Around July 2026, ACG redesigned our Spread Axle Fender to allow the concealment of the fasteners by moving the attachment point to inside the wheel well. This requires a ¾” wide strap to be welded in the faceplate to allow the fasteners to secure the fender.

Redesign Spread Axle Fender (2026)

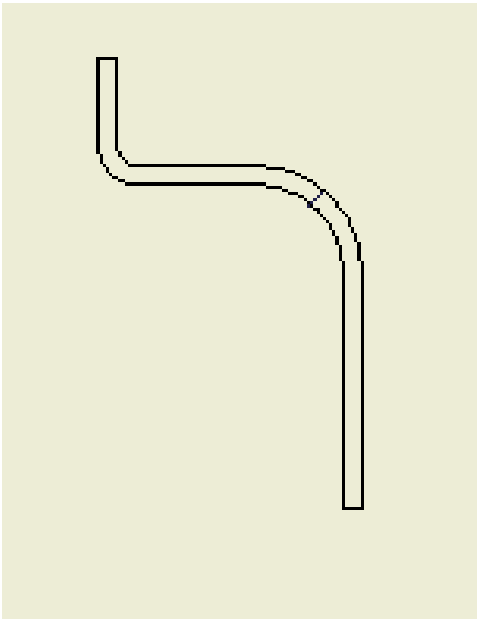
This fender has no return lip to the inside of the wheel box and will have the fasteners present of the face of the fender

This fender has a return lip on the inside of the wheel box and will NOT have the fasteners present of the face of the fender
